## Product Change Notification

### PCN-PCC-277-2017

Business Unit	Product Line Code	Type of Change	Action	Date of Issue
PCC - PCB Connectors	AAA	Product Change Notification	Notify Distributors and Field	2/3/2017

Previous Product	New Product

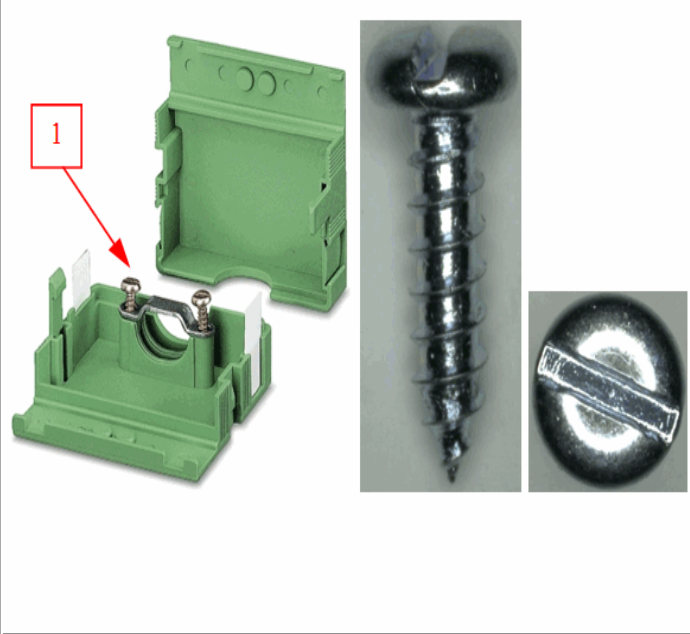
The slotted screws for the strain relief will be changed to Phillips screws. The screwdriver is not laterally guided in the slotted screws. The Phillips screws centered the screwdriver, so it is easier to tighten the screws.
